PRODUCT / PROCESS CHANGE NOTIFICATION

1.1 Company		STMicroelectronics International N.V
1.2 PCN No.	MDG/20/11933	
1.3 Title of PCN	ST25DV-I2C series with Open Drain GPO design improvement	
1.4 Product Category	ST25DV-I2C series with Open-Drain GPO	
1.5 Issue date	2020-01-09

ST25DV-I2C series with Open Drain GPO design improvement

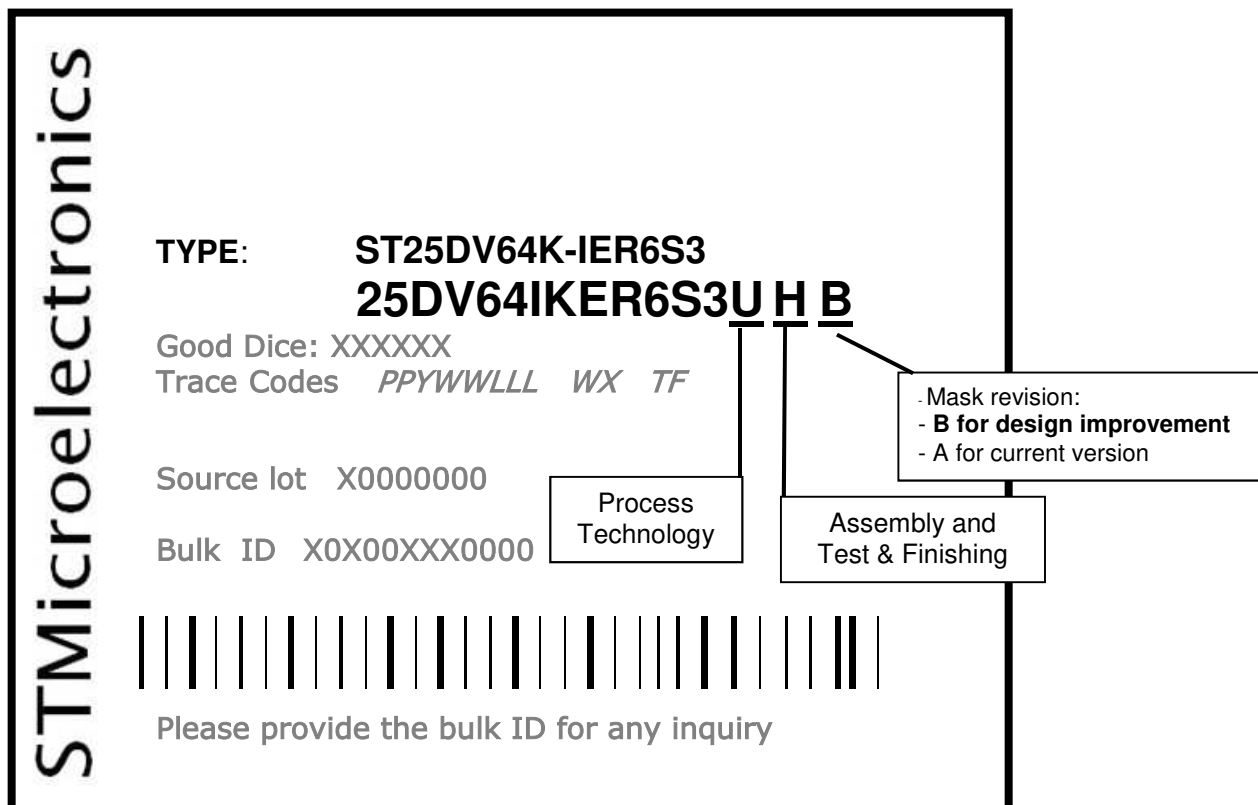
What is the impact of the change?

- **Form:** Marking change on package top side
- **Fit:** No change
- **Function:** No change
